PROJECT **Our Town Hall**

DRAWING TITLE **Princess Street extension link corridor detail sections E-E and F-F**

DRAWING NO. **OTH-PUR-TH-RF-DWG-A-7405 05**

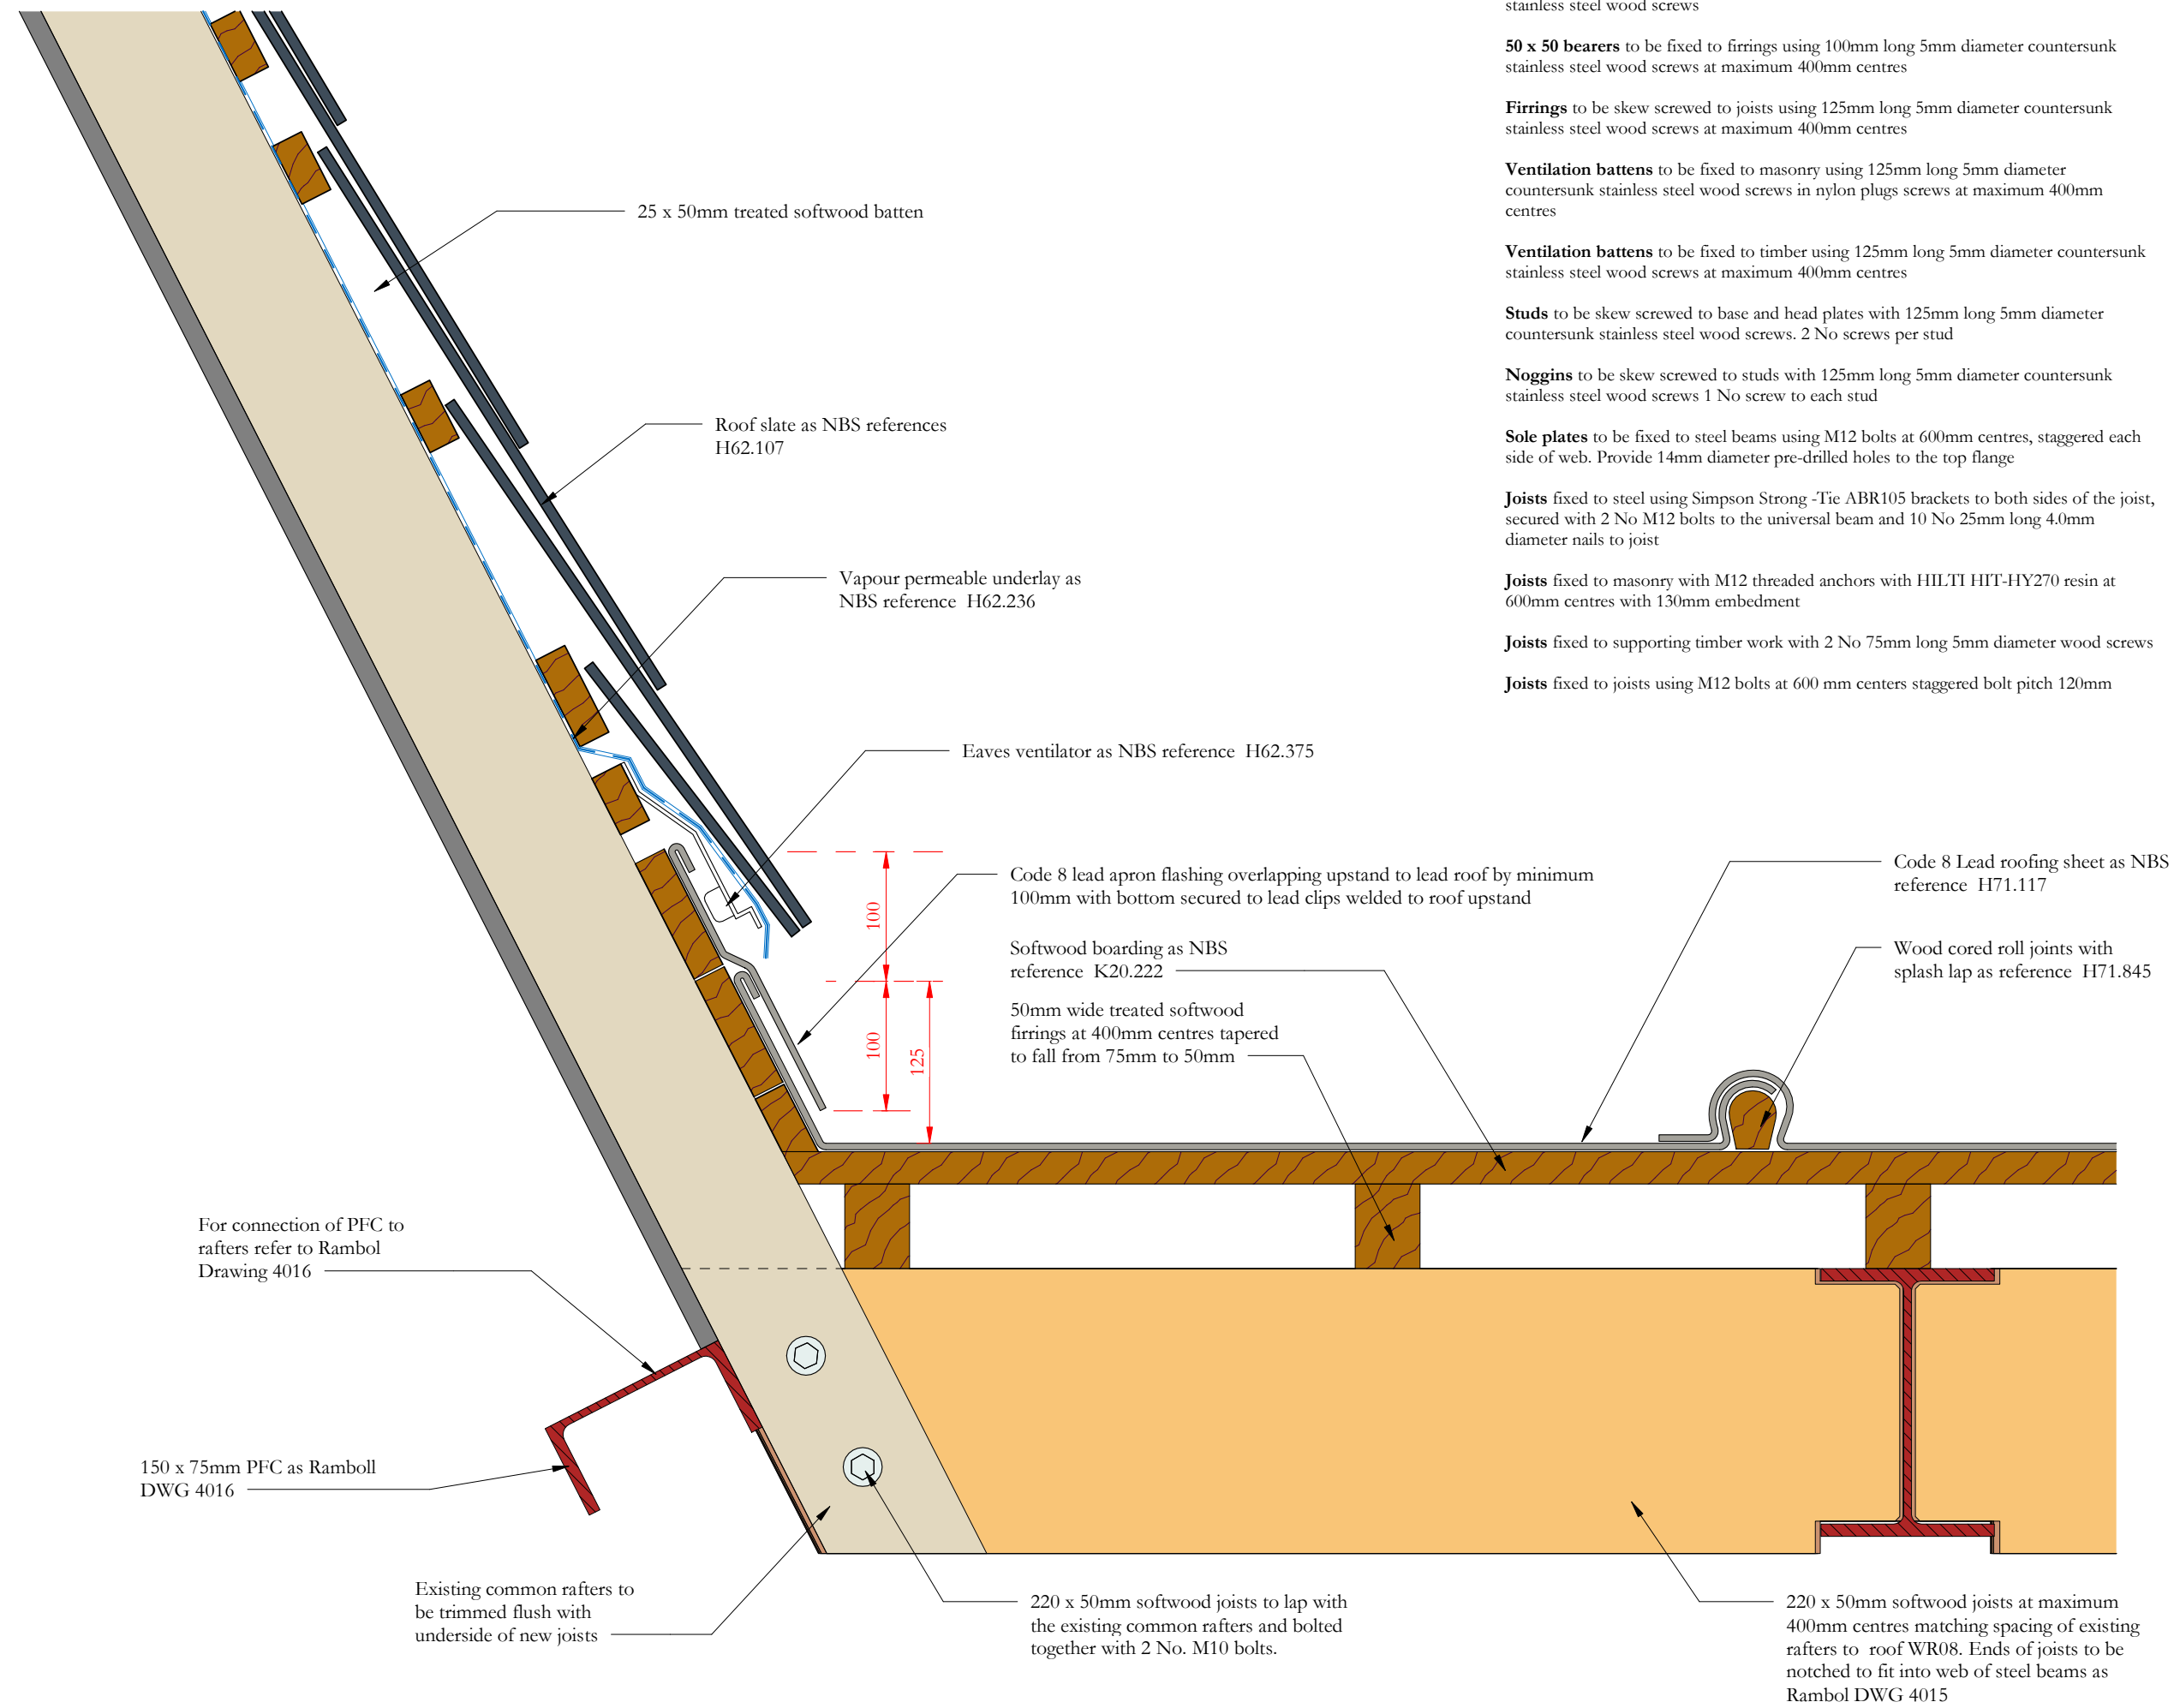
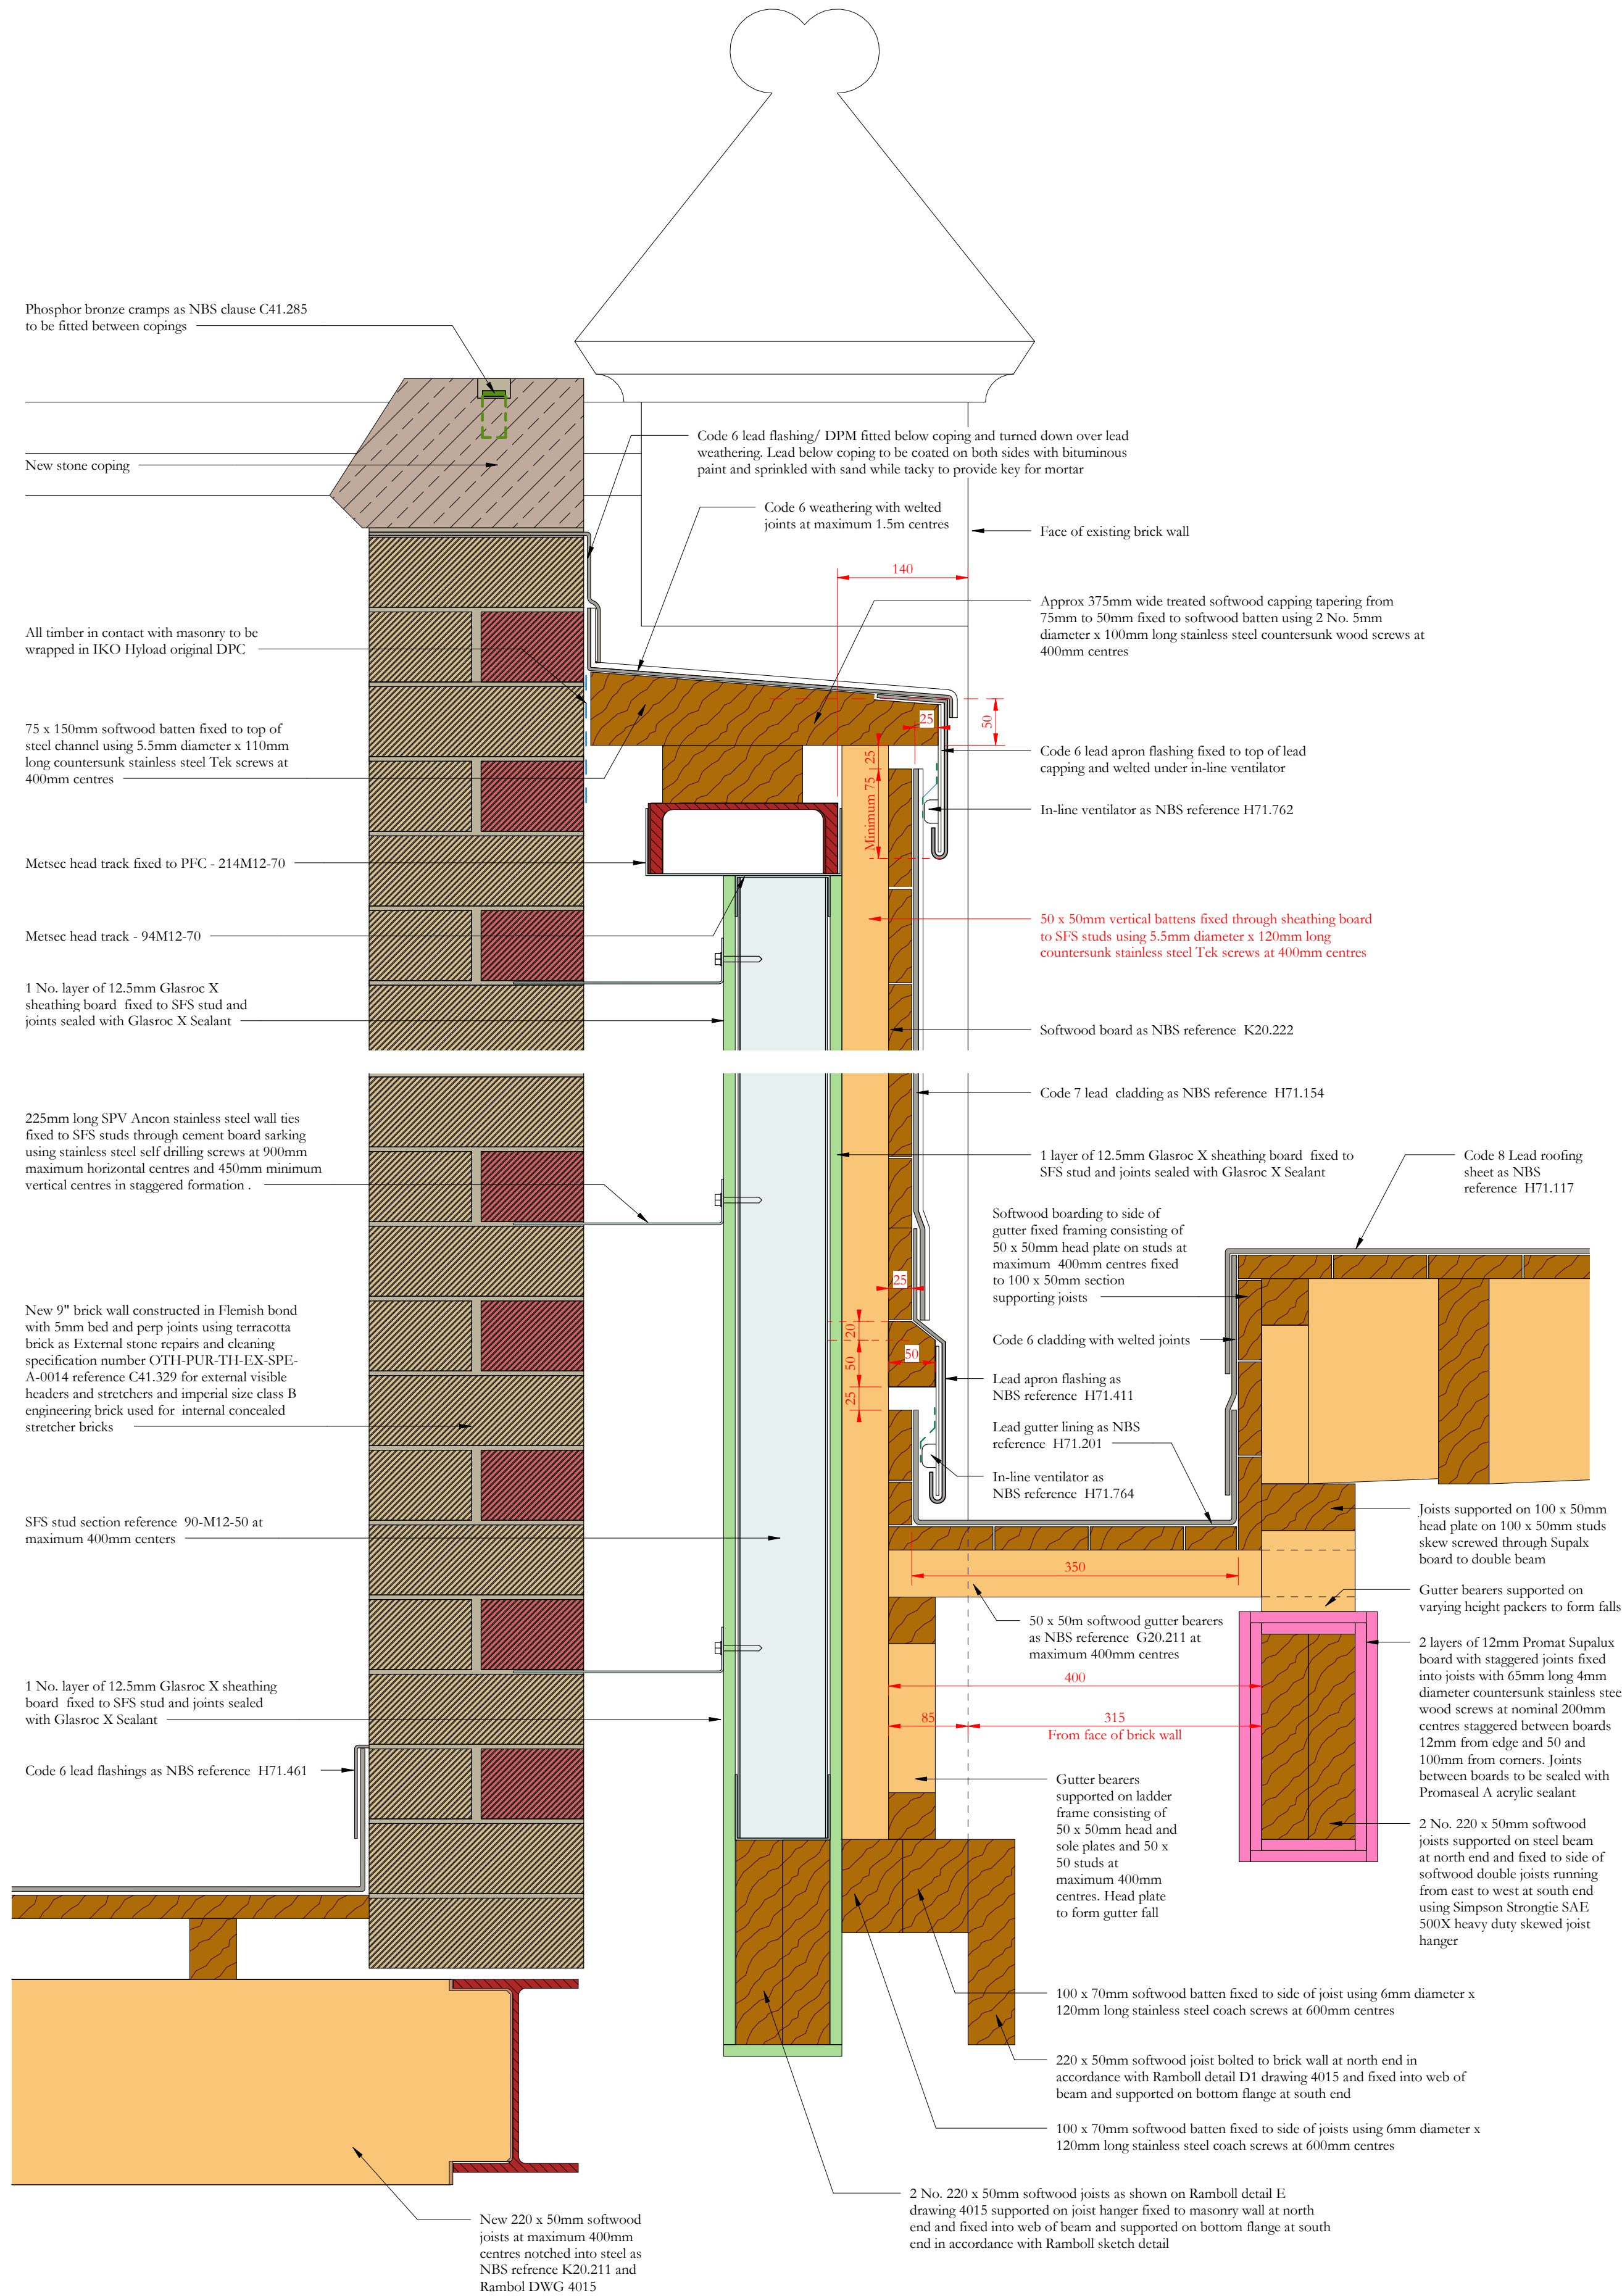
Revision 05: Fixing detail description amended and setting out dimensions added for timber beams supporting gutter and joists. Supalux board encasement added around timber beams. Phosphor bronze cramps added between coping stones

Revision 04: Timber batten shown fixed to top of PFC channel to close cavity. Row of header bricks shown in course on top of steel beam. Notes amended to add fixings for timber battens to steel. Configuration of timber beams supporting PFC and gutter amended. Lead apron flashing added at junction with slate roof

Revision 03: Timber and SFS fixing notes added

Revision 02: Brick tie setting out amended

Revision 01: Sarking board Metsec framing changed from 2 No. layers of cement board to 1 No. layer of Glasroc X
